**Ref: Response to request for review “Power generation from coking waste heat utilization project at Taiyuan Gangyuan Coking & Chemicals Co., Ltd in China” with the Reference Number 1707**

29 July 2008

**Figure 1: Sensitivity Analysis Production Capacity Design Rate**

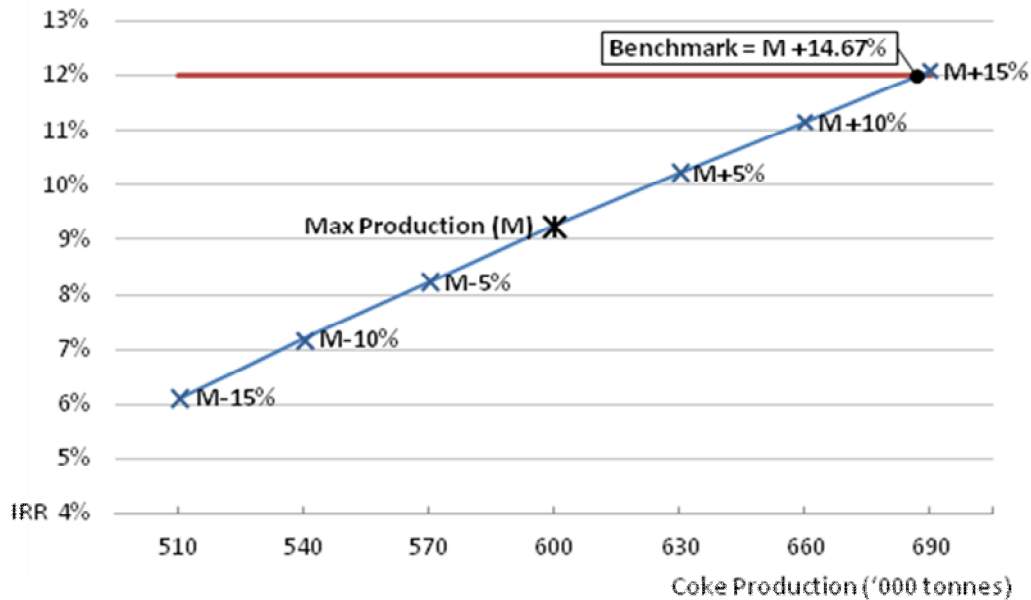
*The PP/DOE shall provide information on the maximum and minimum production capacity design rate of the coke production and apply these values to the sensitivity analysis*

The maximum capacity design rate of the coke production facility is set at 60,000 tonnes per year. The minimum production capacity design rate for the coke oven in this project is zero.<sup>15</sup> This is specified by the project activity’s FSR and bound by the local authority’s official approval for the project (both documents validated by the DOE). The power plant capacity is designed on the basis of the maximum coke production and determined by the power plant design institute of the FSR, the “Shanxi Diwei Electric Power Design Institute”, which has substantial experience with these types of project.

A sensitivity analysis on the maximum coke production has been included in the updated spreadsheet previously submitted to the DOE. **Figure 1** shows the results of the sensitivity analysis.

The IRR of the project exceeds the benchmark in the scenario that coking production reaches 14.67% over its estimated maximum capacity. This result meets the general point of departure as outlined in the EB’s *Guidance on the assessment of investment analysis* which suggests that variations in the sensitivity analysis should at least cover a range of +10% and

In conclusion it is therefore unfeasible that realized coke production would exceed the maximum capacity design rate by 14.67%. Apart from that this would contradict the FSR and relevant approvals, such a large variation for a facility of this type and size would be unlikely. The amount of power generated is also restricted by the design of the power generation facility.

**Figure 2: Detailed Project Implementation Timeline**

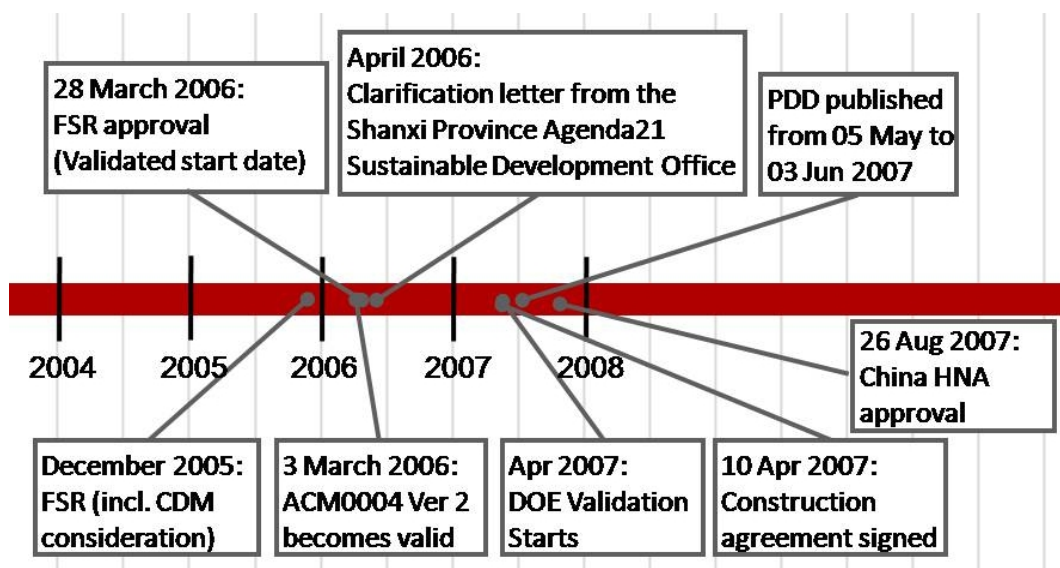
The DOE is requested to provide further explanation to show that CDM revenues were considered essential in the decision to invest in the project activity. The response should provide a detailed timeline of project implementation with relevant, preferably third-party evidences.

A detailed timeline of the project implementation is provided in **Figure 2**. This timeline has been validated by the DOE.

A feasibility study report (FSR) for the project activity was undertaken in December 2005 to determine the economic viability of a waste heat recovery plant at the project owner's coking facility. This FSR was validated by the seriously considered the potential benefit of CDM in the investment consideration.

The project owner therefore seriously considered CDM revenues for its investment decision in December 2005, basing the decision on the FSR. A clarification letter from the Shanxi Province Agenda21 Sustainable Development Office (under the Provincial Development and Reform Committee) dated April 2006 confirmed that the project had started the CDM
